# *Interactive comment on* "Comparison of Vaisala radiosondes RS41 and RS92 at the ARM Southern Great Plains Site" by M. P. Jensen et al.

Response to comments from Anonymous Referee #2 on "Comparison of Vaisala radiosondes RS41 and RS91 at the ARM Southern Great Plains Site" by M. P. Jensen et al.

**Fig. 1.** Figure A Vertical profiles of the median (black), 25/75th percentile (green) and 10/90th percentile (grey) differences between GRUAN- processed RS92 and original RS41 observations (RS92-RS41)

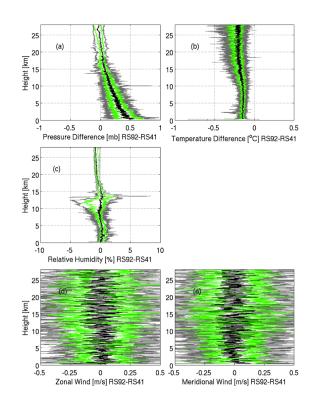
[3] Referee #2 writes, "The conclusion and abstract state, that there will be no significant impacts in the switch from the RS92 to the RS41. This statement only applies to the currently used MW31 version 3.66, but not for the MW31 version 3.62, which has been used until 2011. The changes between these two Vaisala RS92 versions strongly impact long-term climate data series, and therefore, this change must be evaluated as well. The authors must point out that there already is an inconsistency in the RS92 record, which has not been properly accounted for. The ARM radiosoundings are also part of the GRUAN network and these data have been processed by GRUAN using an independent processing system, which considers these inconsistencies. All

ARM RS92 data have been or are scheduled to be reprocessed using this processing system. Therefore, the comparison between RS41 and RS92 should also refer to the GRUAN processed ARM data, which do not suffer from changes in processing version (3.62 to 3.66) or changes in sensors (coating of humidity sensors). A comparison to the GRUAN processing of the same data is required if the authors truly want to make a statement that there will not be significant impacts on the long term series in switching from the Vaisala RS92 to the Vaisala RS41. As is, their statement is somewhat misleading and only refers to the changes between Vaisala RS92 processing MW31 3.66 to Vaisala RS41 processing MW41 2.1, which is valid only for the last four years, but not for the entire ARM RS92 data record.

[16] Referee #2 writes, "Page 11336, line 8: The authors should not only make use of the other measurements at the site, but in particular of the different RS92 processing provided by GRUAN for ARM. Since ARM SGP is formally a site within GRUAN, all data are also processed by GRUAN and these data are available to the authors. It would be most useful to make use of this processing, since this processing is more self-consistent than the operational Vaisala processing."

For completeness, we have obtained the GRUAN processed RS92 radiosondes and compared to both the Vaisala processed RS92 and the RS41 radiosonde observations. For pressure measurements, the GRUAN corrections are smaller than 1 mb for nearly 97% of the measurements in this intercomparison. For most measurements, especially below 10 km the GRUAN processed pressure measurement is less than the original measurement. For temperature measurements, the GRUAN processed data decreases the temperature measurement less than 0.5oC for nearly 95% of the observations in this intercomparison. For relative humidity the GRUAN processing produces differences less than 5(2)% for more than 96(91)% of the measurements in the intercomparison. Above 15 km the GRUAN corrected value is generally greater than the original RS92. The GRUAN processed soundings result in larger differences from the RS92 than that between RS92 and RS41. Here we show the comparison of the GRUAN processed RS92 and the RS41 sounding observations in Fig. A. Compared to the differences without the GRUAN processing, the pressure comparison indicated that the RS41 are generally lower than the GRUAN calues in the lower troposphere, the temperature measurements show the RS41 measurements warmer than the GRUAN processed values at all levels, the RH differences are similar with an without GRUAN processing and the wind differences show larger differences following the GRUAN processing at all heights.

Changes: We have changed the last sentence of the abstract to more specifically state. "For a majority of science applications, particularly those of users of ARM data, the differences between the RS92 and RS41 measurements should have little impact." We have also edited the conclusions to state, "For many science applications, particularly those of users of ARM data, the described differences between RS92 and RS41 will have little impact, however, for long-term trend analyses of atmospheric thermo-dynamic quantities additional characterization of the RS41 measurements and their relation to the long-term observational records will be required. "

**Fig. 2.** Figure B Relative difference in relative humidity between the RS92 and RS41 sondes as a function of temperature for four difference relative humidity ranges.

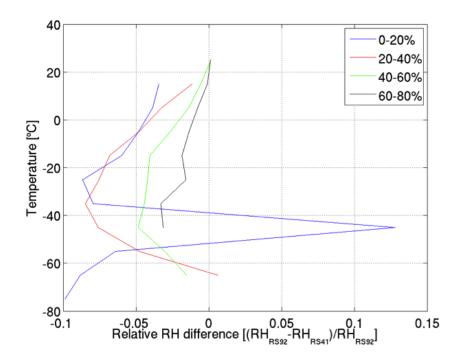
[20] Referee #2 writes, "Figure 18: Since RH over liquid at ice saturation decreases with temperature, it would be better to show the RH difference as relative difference, not as absolute difference. It would be most enlightening, if the authors would also include the GRUAN processed data in this figure."

Reply: We duplicated this figure using relative differences rather than absolute differences (Fig. B). This version of the figure is more difficult to explain, and the language can quickly get confusing (e.g. relative differences of relative humidity). The new figure also reduces the dynamic range of the resulting differences and does not tell a different story, so we have chosen to leave the original figure.

Changes: None.
